Subject: Review meeting 7/16/19 Lavitt property PV Planning from Phil Hagenah

Re: Preliminary Plat for Lavitt Manor II—Two Lot Subdivision: 7525 N. Ironwood Drive

5. PUBLIC HEARINGS 19-302 CONSIDERATION OF PRELIMINARY PLAT

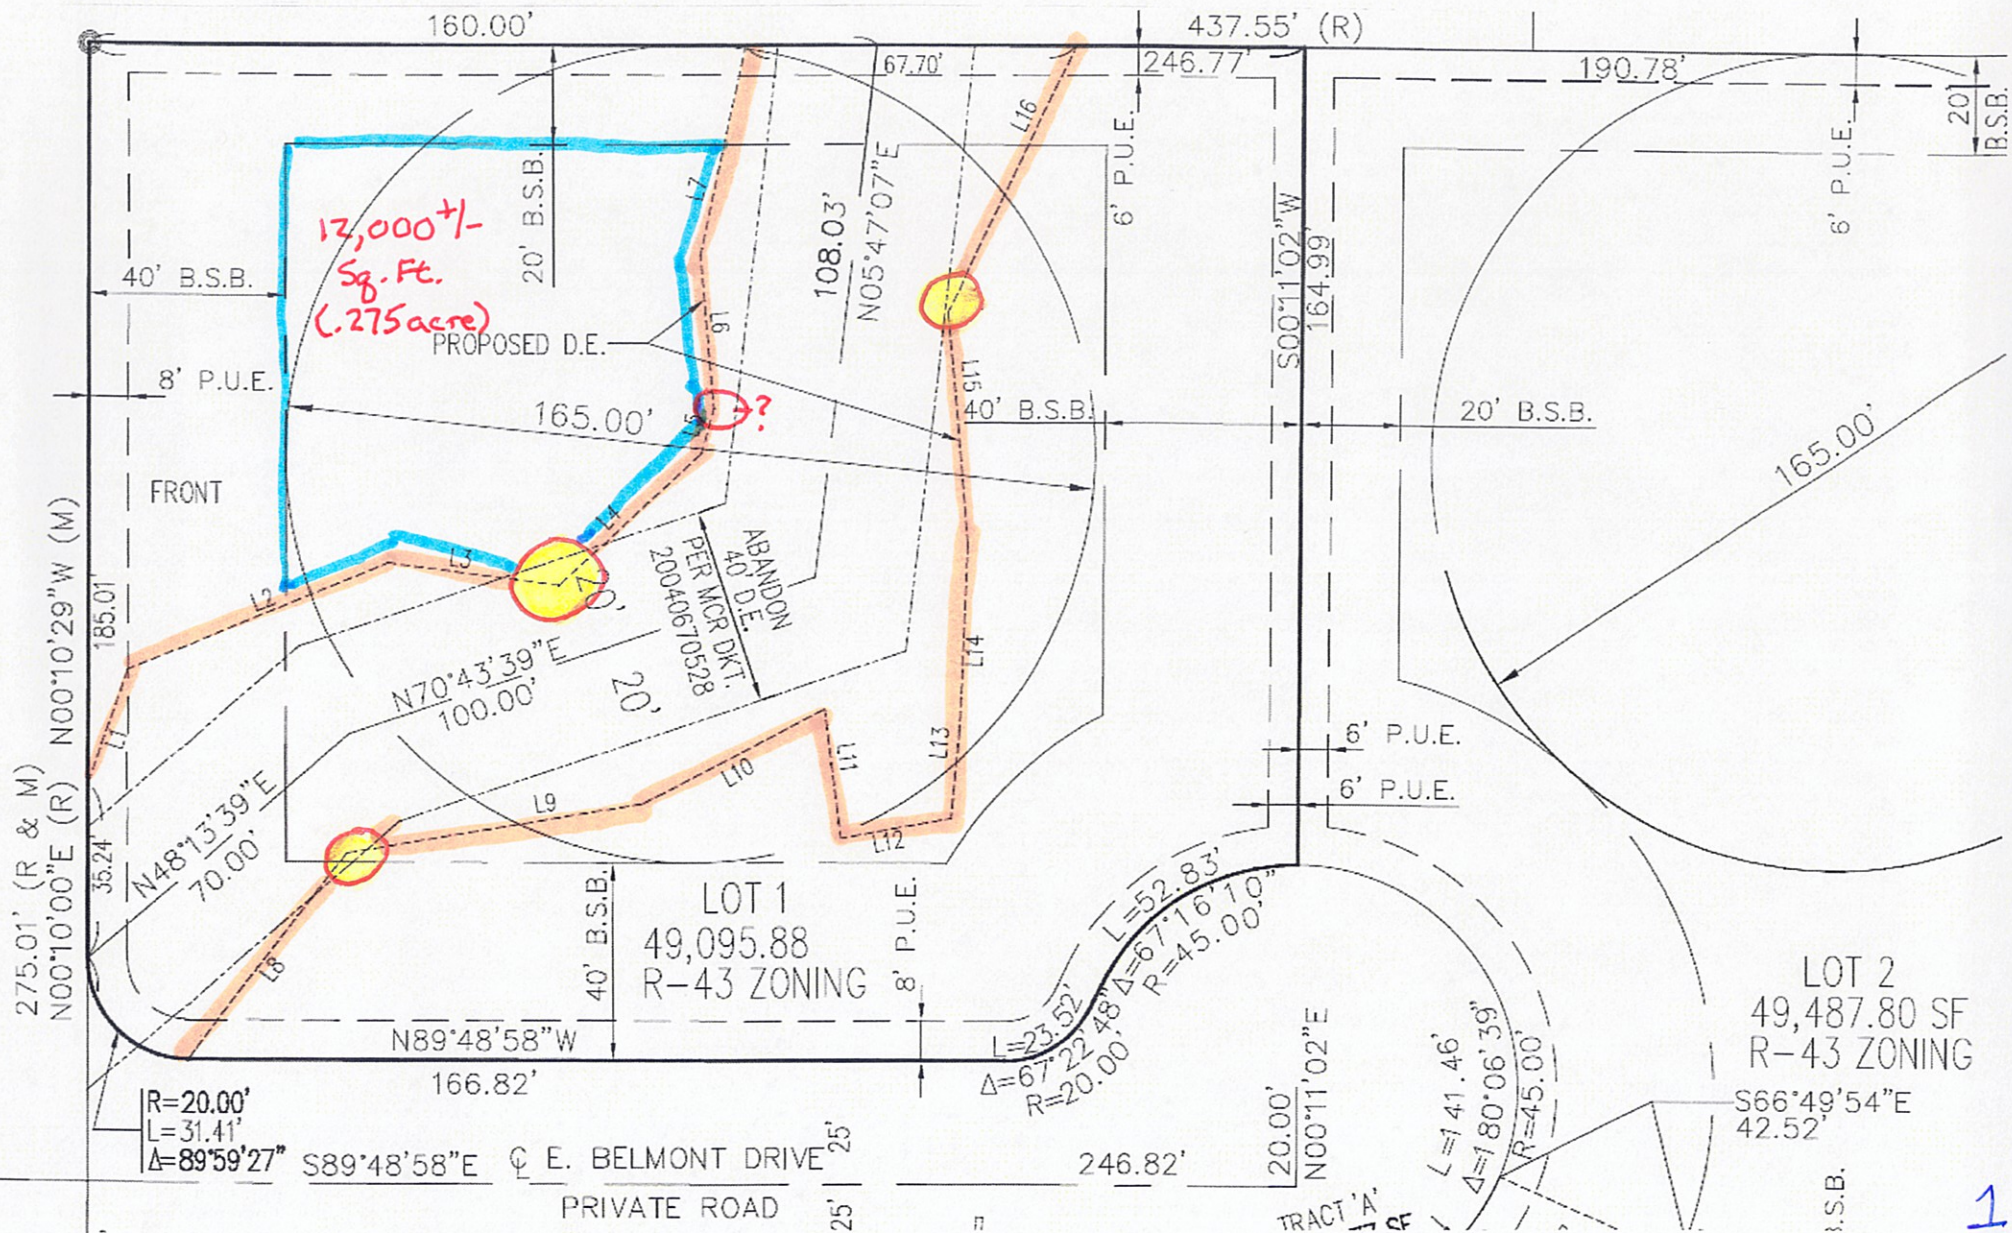
- Town of Paradise Valley is obtaining easement on Lot 1;
- Mandatory language ("shall") to have a 5 foot landscape buffer on each side of wash;
- Current easement points approaches or encroaches Natural Wash at 3 points thus the landscape buffer is not appropriate;
- Plan should not be approved as it violates the Town Code.

9
C.3

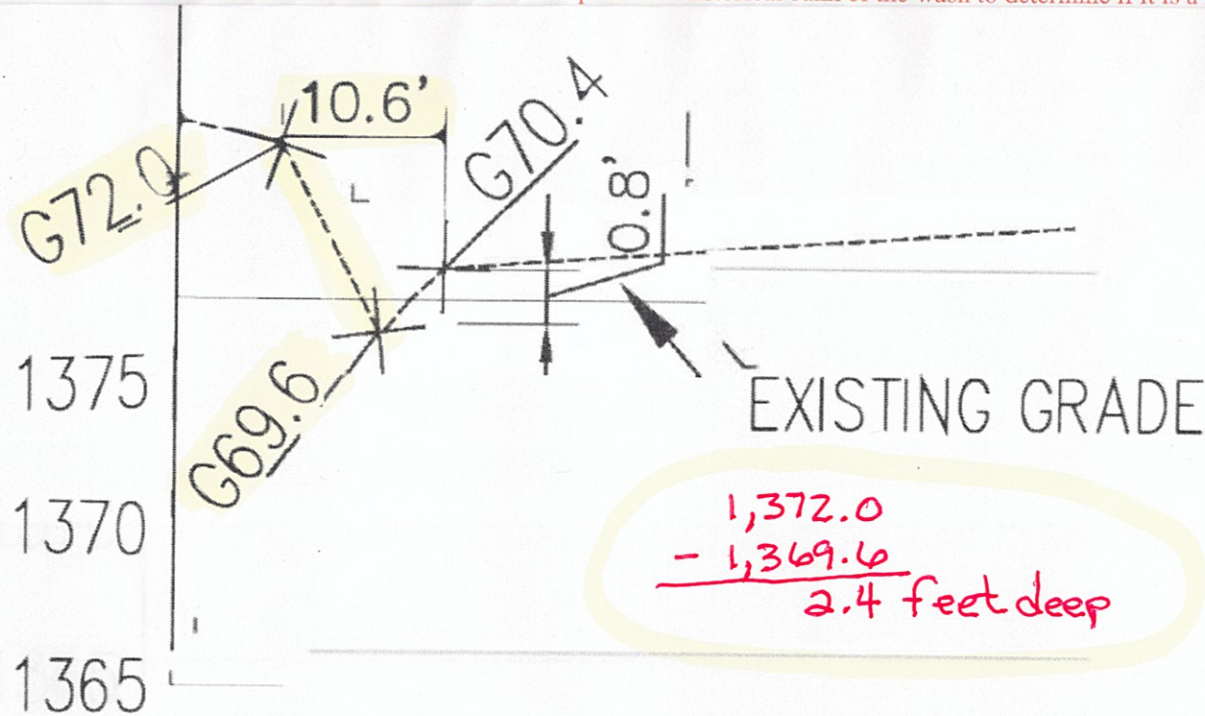
- Must consider both "historical banks" to determine depth;
- Nowhere does it say watercourse depth is taken from one bank, lowest bank, or existing grade of one bank.

- Width must be determined by taking a measurement at the "top of the bank";
 - Can only mean at the top of each bank, or one could not obtain a width measurement from one bank.
- Accordingly, to ensure the same "top of the bank" meaning throughout the provisions, "top of the bank" must mean top of each bank;
 - Depth measurements must be taken from the top of each historical bank of the wash.

- Width must be determined by taking a measurement "to the top of the bank";
 - Can only mean to the top of each bank, or one could not obtain a width measurement from one bank.
- Accordingly, to ensure the same "top of the bank" meaning throughout the provisions, "top of the bank" must mean top of each bank;
 - Depth measurements must be taken from the top of each historical bank of the wash to determine if it is a Natural Wash.

PAVING GRADING DRAINAGE LAVITT MANOR II

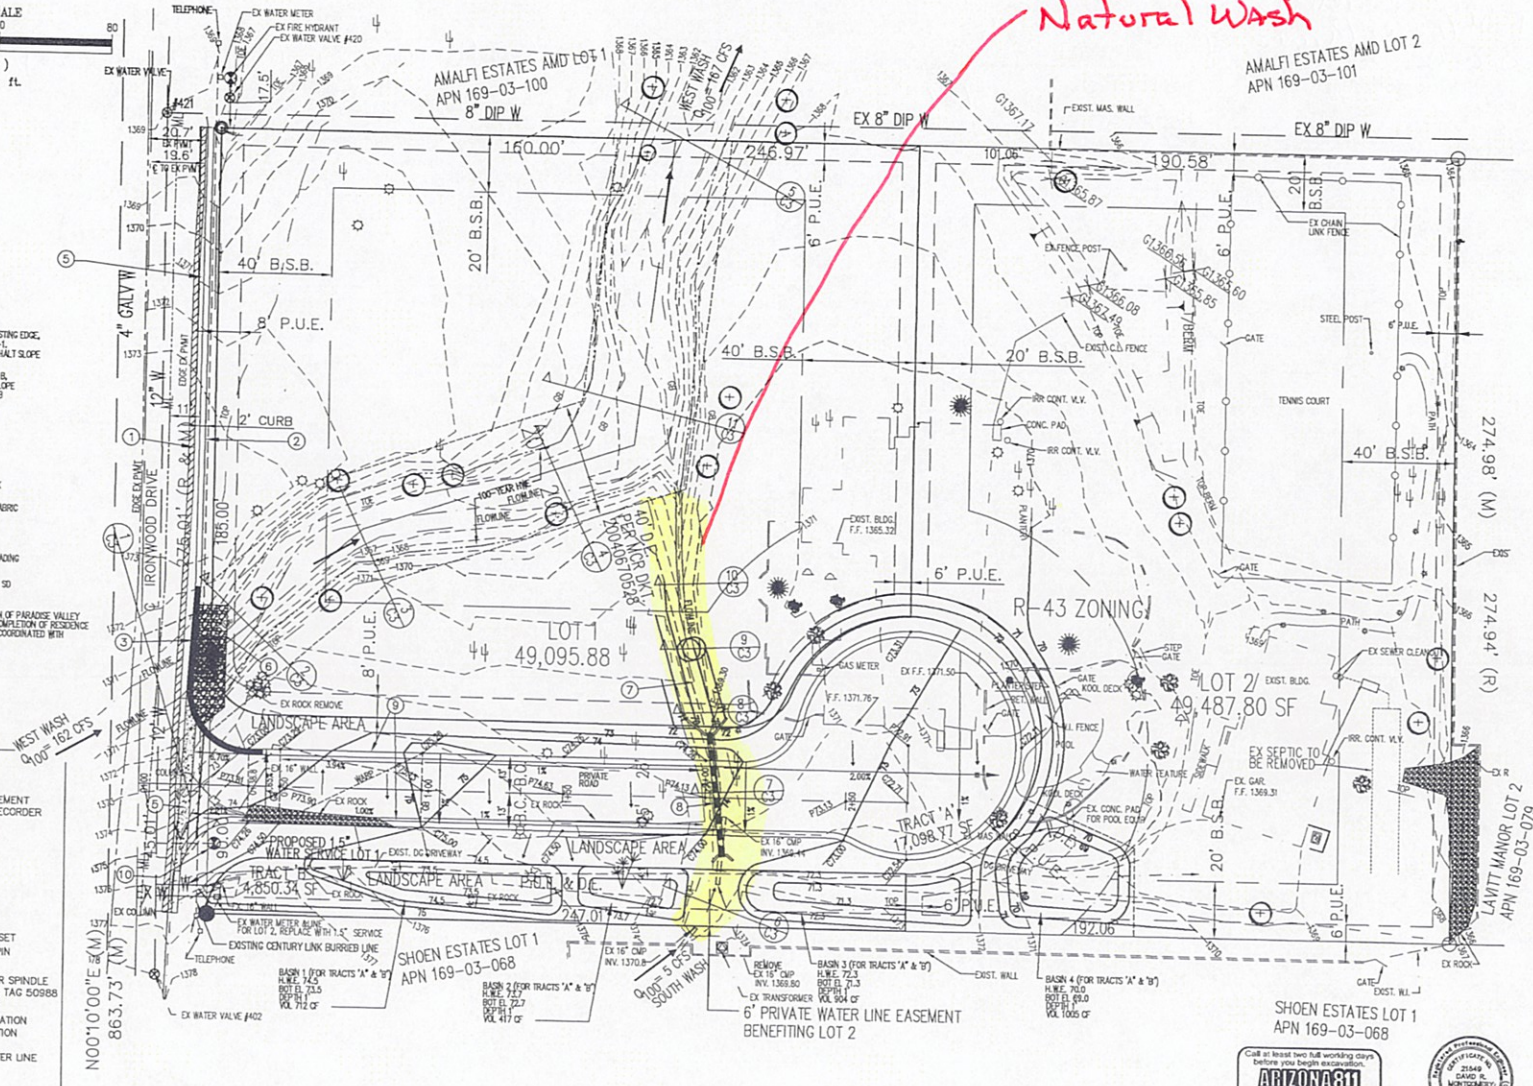
Does NOT show REQUIRED Landscape Buffer here or on plat 3-6(3) STORM DRAINAGE Design Manual

Suspected
Natural Wash

Did NOT provide LANDSCAPE BUFFER OR
EQUALLY SPACED CROSS SECTION ACROSS ENTIRE WASH

PAVING GRADING DRAINAGE LAVITT MANOR II

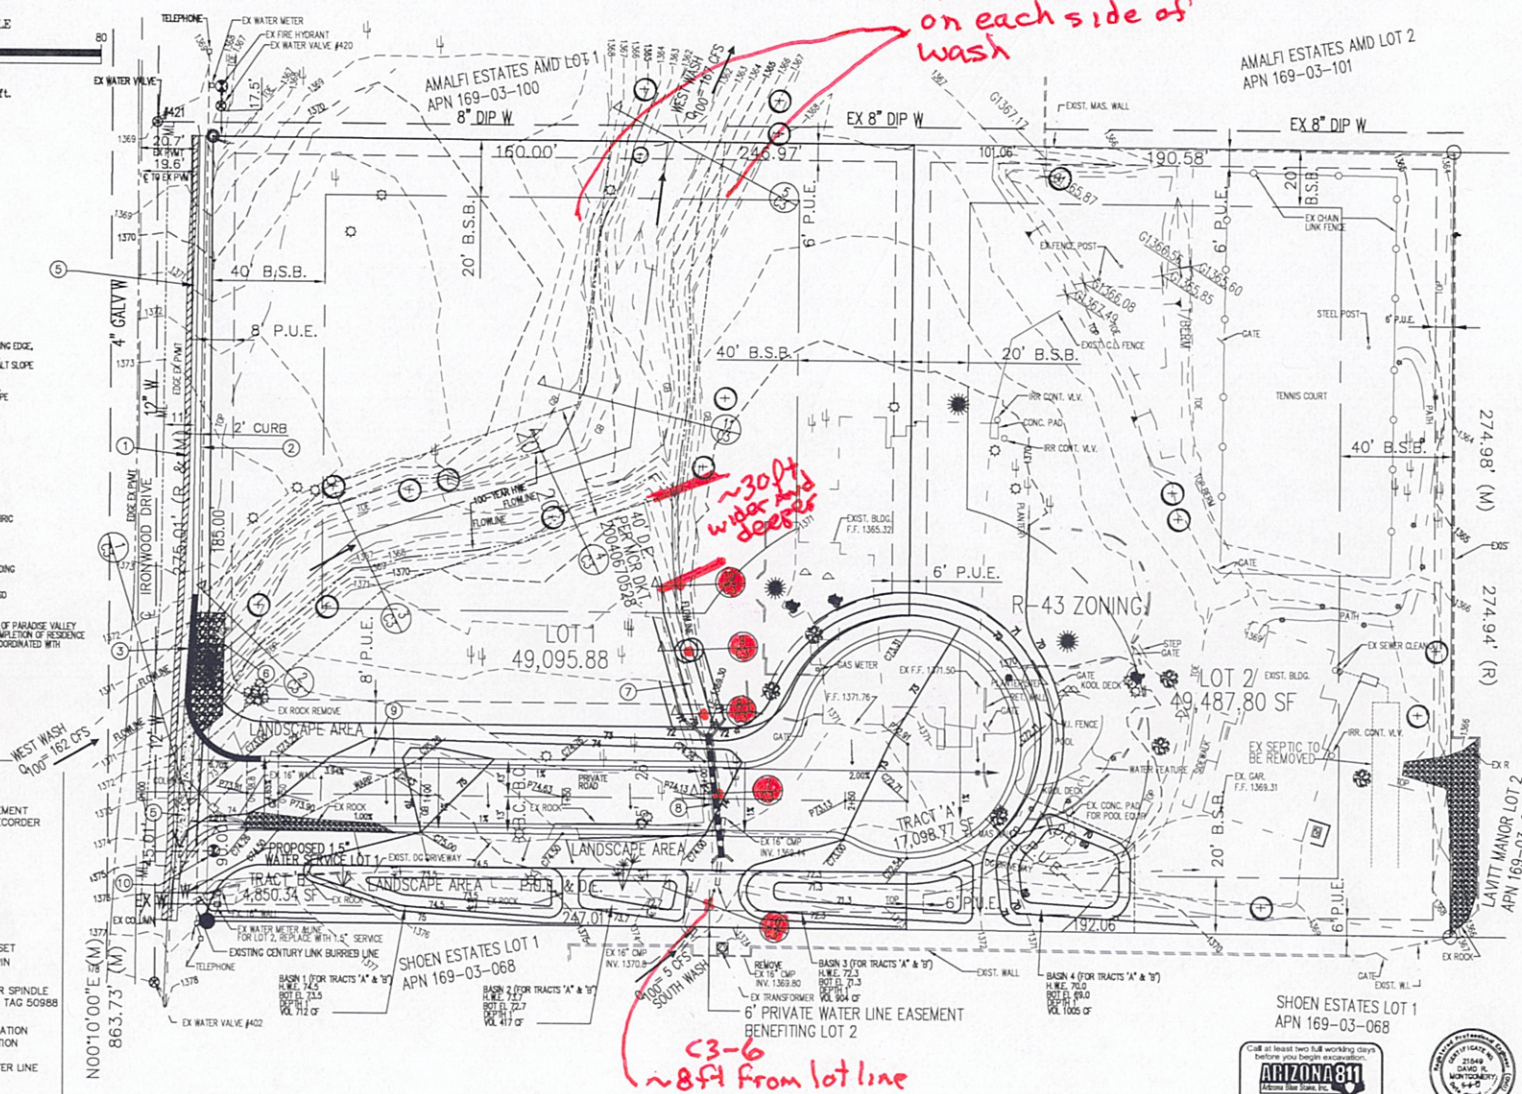
no buffer of 5'
on each side of
wash

~30ft
wider and
deeper

C3-6
~8ft from lot line

DRAWING NO.
C30f4

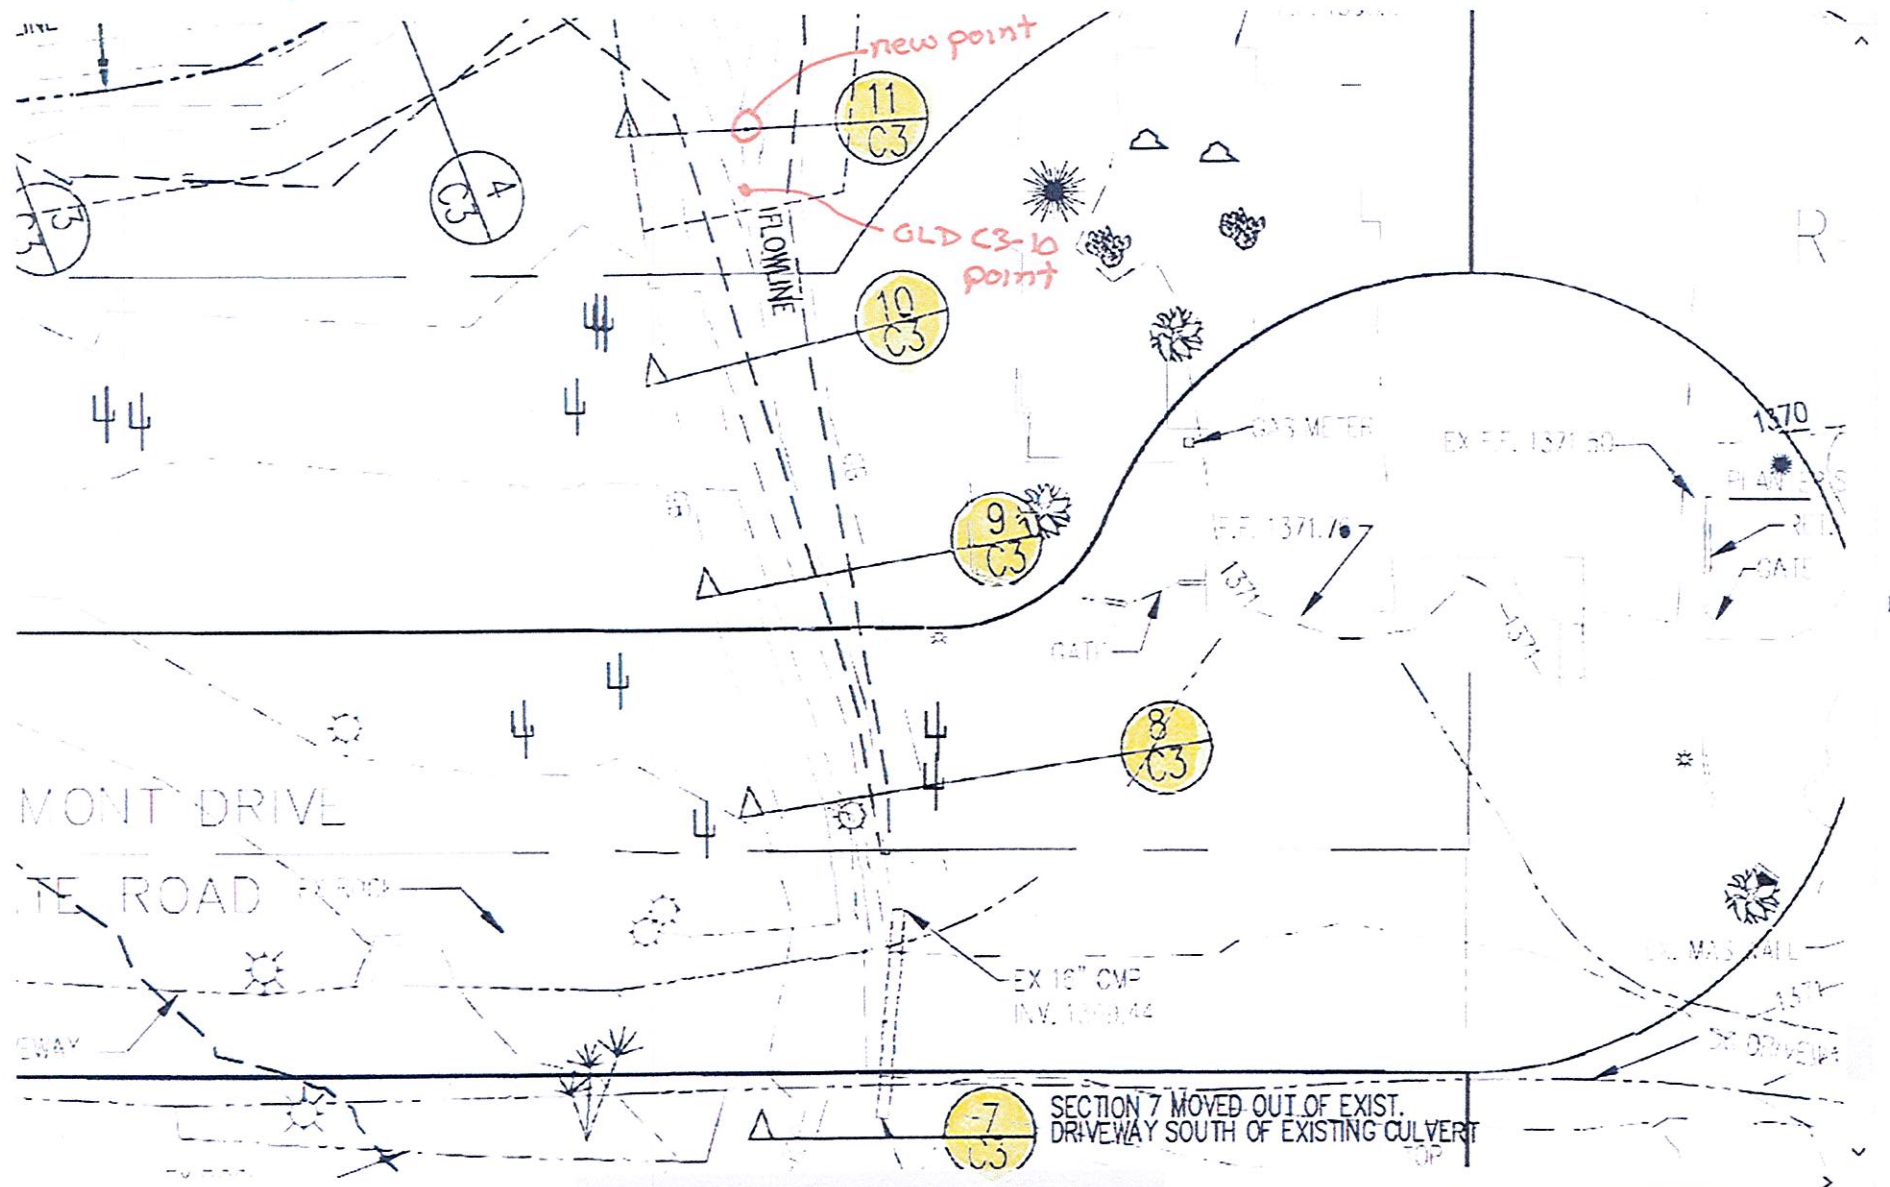
**SUMMARY OF PLAT POINTS
FOR
SOUTHERN DRAINAGE CHANNEL**

Plat Points	Elevation Pt. 1	Elevation Pt. 2	Depth of Wash	Width of Wash
C3-7	1373.2	1369.8	3.4 feet	18.5 feet
C3-8	1373.0	1369.7	3.3 feet	8.5 feet
C3-9	1372.0	1369.6	2.4 feet	10.6 feet
C3-10	1371.0	1369.3	1.7 feet	12.0 feet
C3-11	1370.1	1368.2	1.9 feet	14.0 feet

9
(C.3)

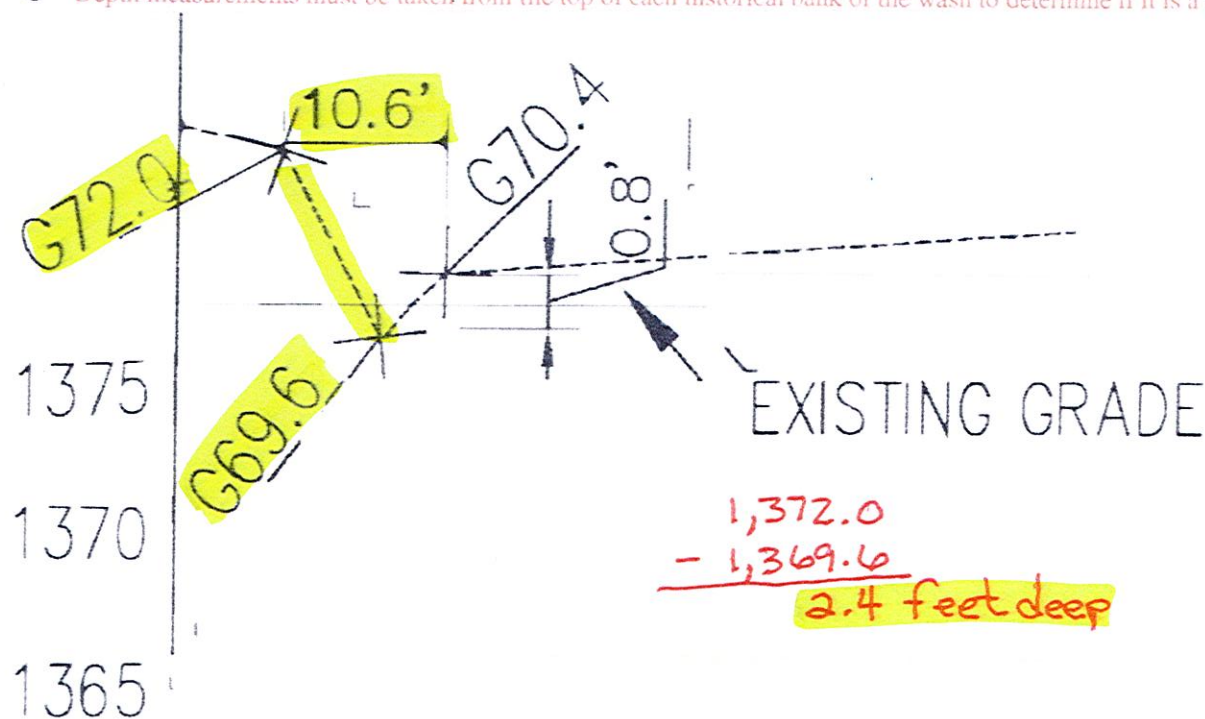
- Must consider both "historical banks" to determine depth;
- Nowhere does it say watercourse depth is taken from one bank, lowest bank, or existing grade of one bank.

- Width must be determined by taking a measurement at the "top of the bank";
 - Can only mean at the top of each bank, or one could not obtain a width measurement from one bank.
- Accordingly, to ensure the same "top of the bank" meaning throughout the provisions, "top of the bank" must mean top of each bank;
 - Depth measurements must be taken from the top of each historical bank of the wash.

- Width must be determined by taking a measurement "to the top of the bank";
 - Can only mean to the top of each bank, or one could not obtain a width measurement from one bank.
- Accordingly, to ensure the same "top of the bank" meaning throughout the provisions, "top of the bank" must mean top of each bank;
 - Depth measurements must be taken from the top of each historical bank of the wash to determine if it is a Natural Wash.
